re: **Excavation, Grading and Drainage Plan Review**
Proposed Residential Development
100 Steacie Drive, Ottawa, Ontario

file: PG5788-MEMO.03 Revision 2

Project		PG5788 - 100 Steacie Drive	
Group		Section A - Static Analysis	
Drawn By	PT	Company	Brigil
Date	04/2026	File Name	Slope Stability Assessment

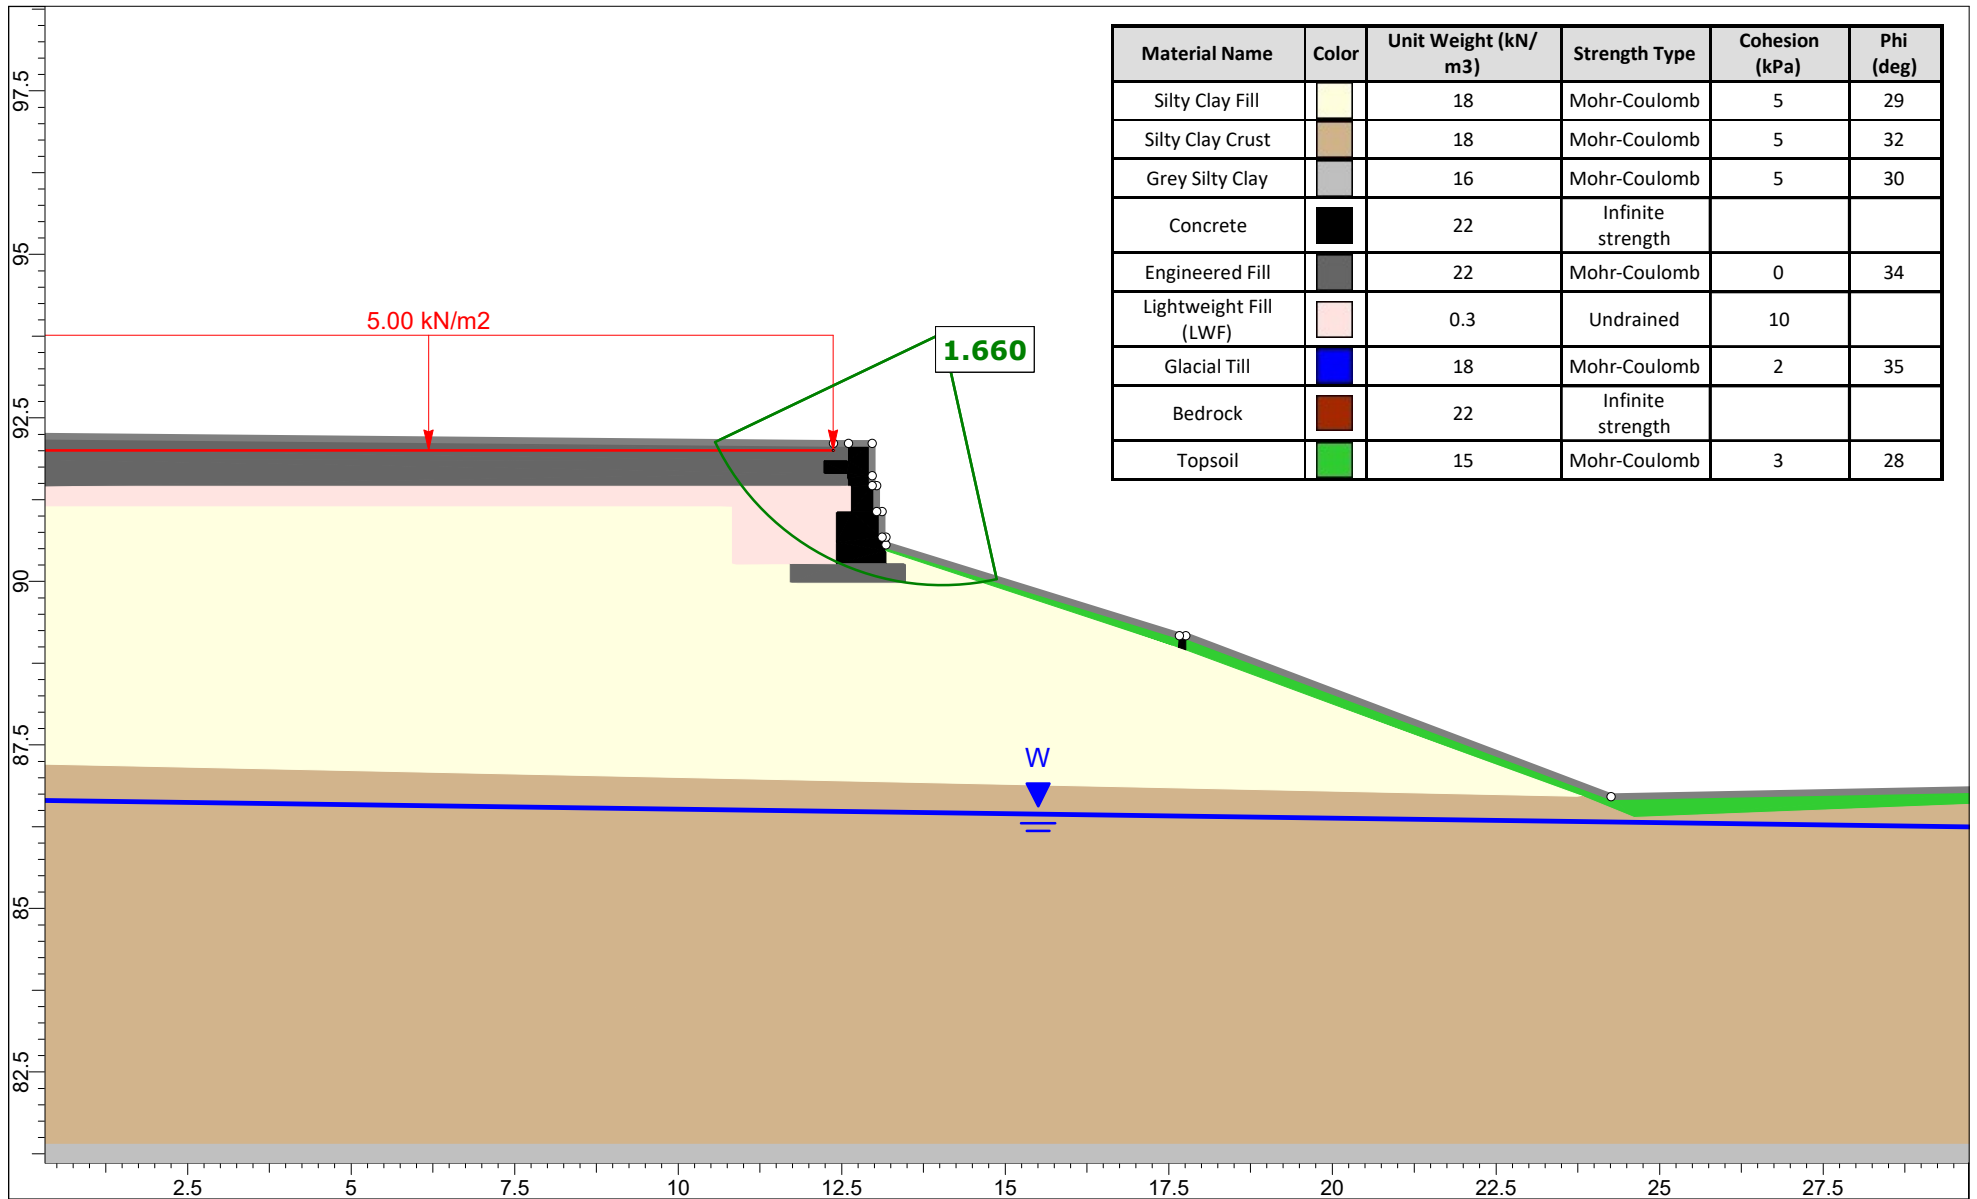
Based on the above-noted information, Paterson completed a slope stability analysis, based on one (1) critical cross-section being considered as the worst-case scenario for slope stability.

The static and seismic analysis results for slope cross-section A are presented in the figures attached below. In summary, the factor of safety for the slope was more than 1.5 under static conditions and more than 1.1 under seismic conditions.

Project		PG5788 - 100 Steacie Drive	
	Group		Section A - Seismic Analysis	
	Drawn By	PT	Company	Brigil
	Date	04/2026	File Name	Slope Stability Assessment

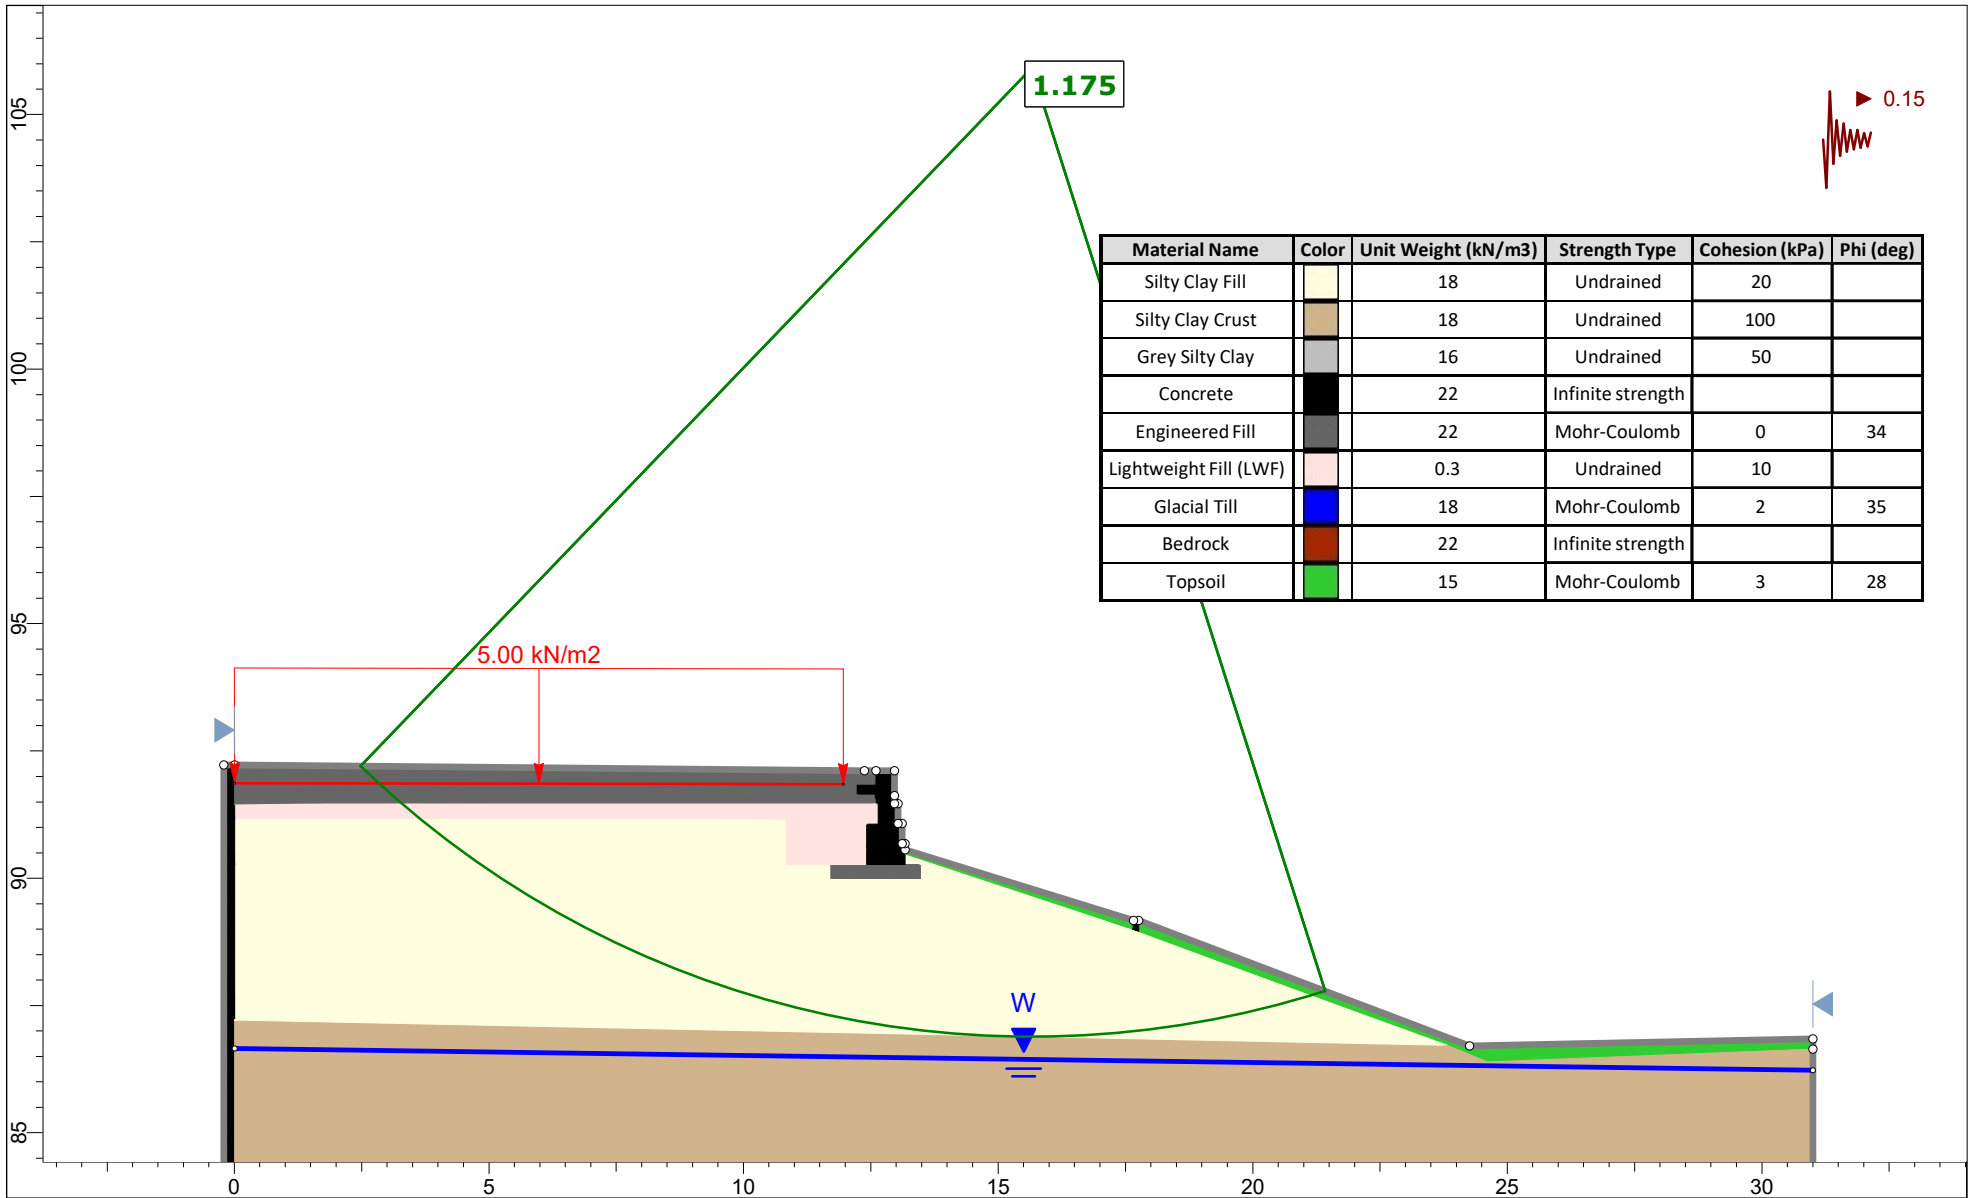
An analysis considering seismic loading was also completed. A horizontal acceleration of 0.15 g was considered for the sections for the seismic loading condition in accordance with OBC 2024. A factor of safety of 1.1 is considered to be satisfactory for stability analyses including seismic loading.

LIGHTWEIGHT FILL DETAIL

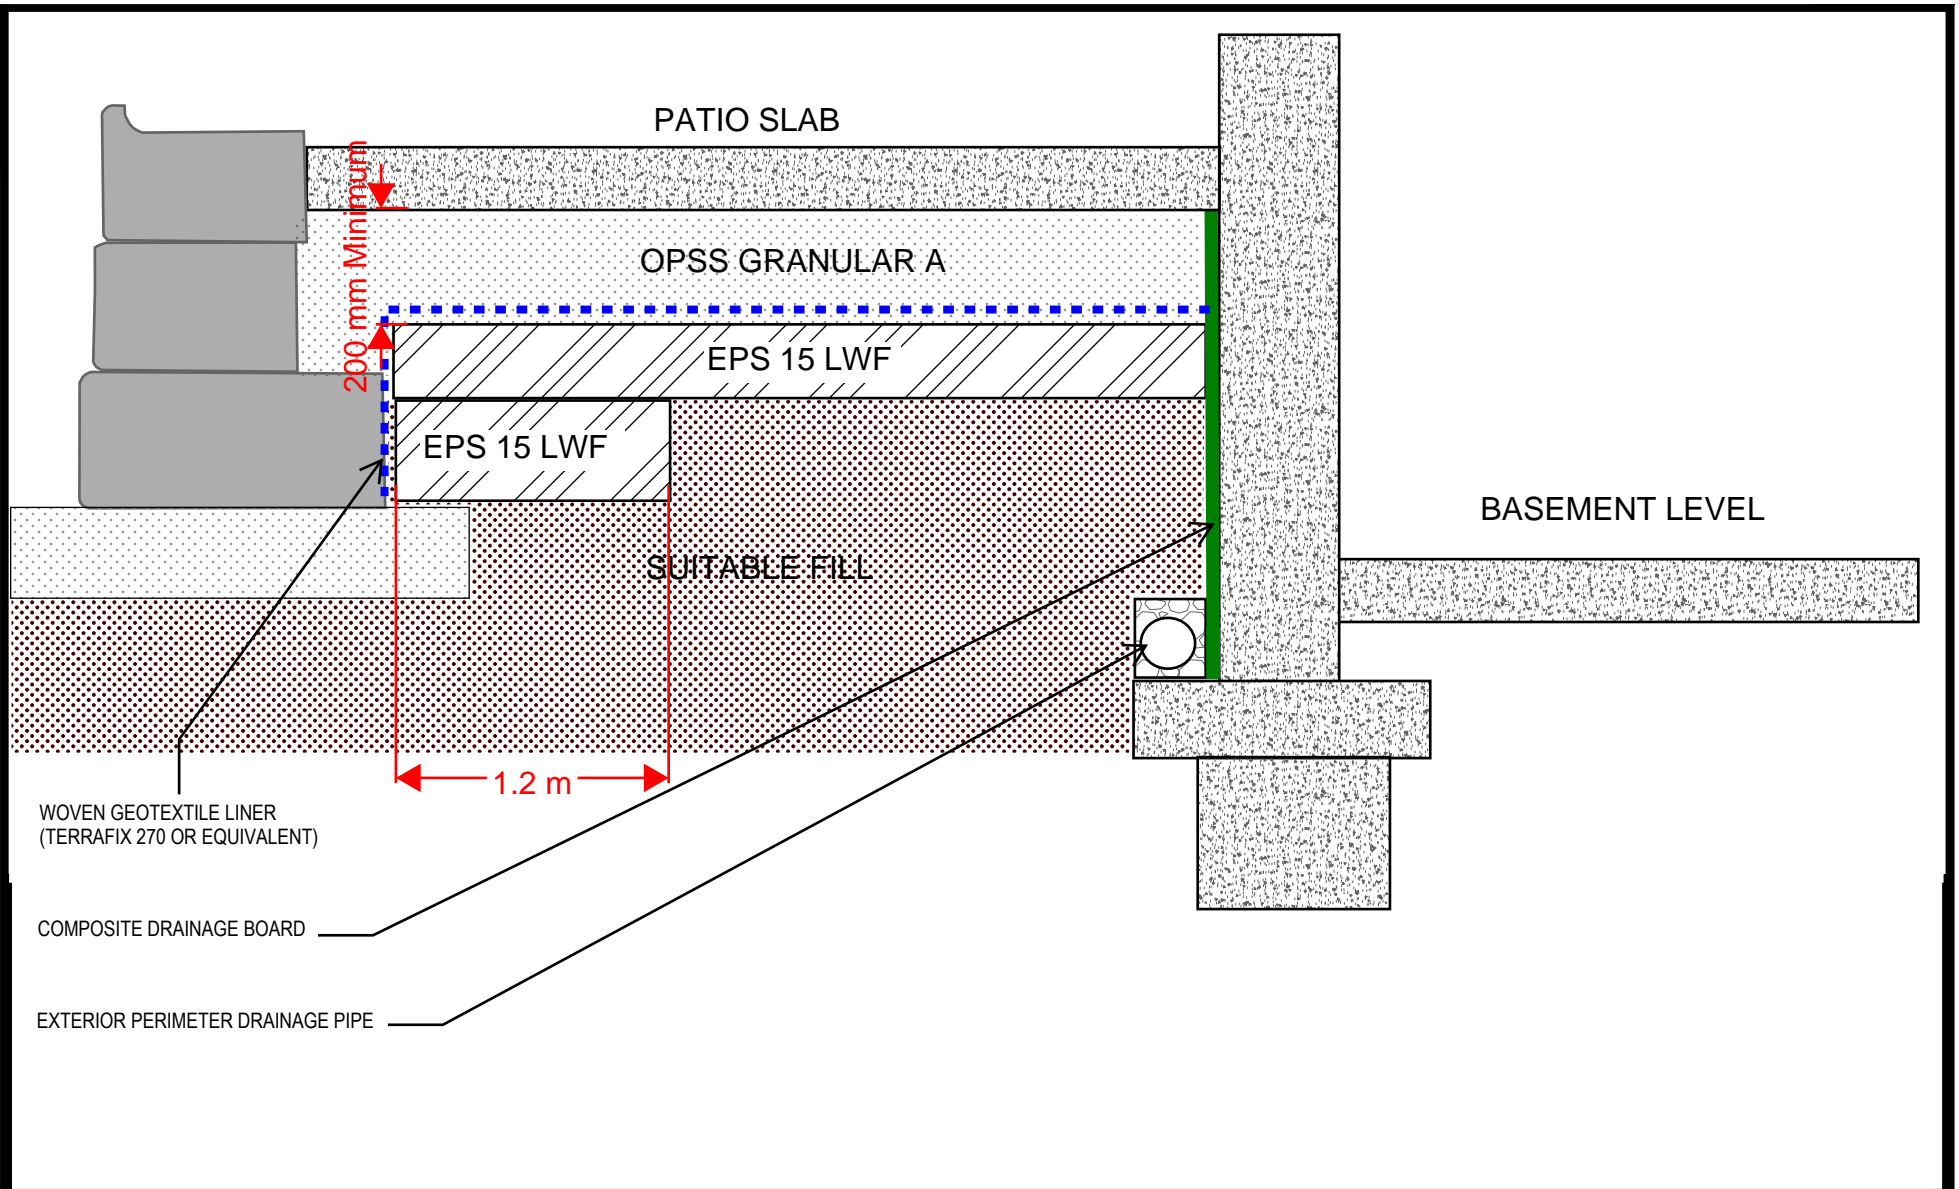
To mitigate the settlement in the landscaping areas, some lightweight (LWF) will be required surrounding the proposed retaining walls and the hardscaped areas located along the north and northeast side of the building. The LWF material should consist of EPS 15.

Reference should be made to the attached grading plan markup and LWF details attached below for the required LWF thickness within the respective areas.

It is not recommended to plant medium to large trees directly above the LWF EPS. The EPS should be covered with a polyethylene sheet and surrounded with a non-woven geotextile such as Terrafix 270R.

A minimum of 200 mm of OPSS Granular A should be placed above the LWF under the hardscaped areas and a minimum 200 mm of approved fill material and a minimum of 100 mm of topsoil should be placed under landscaped areas.
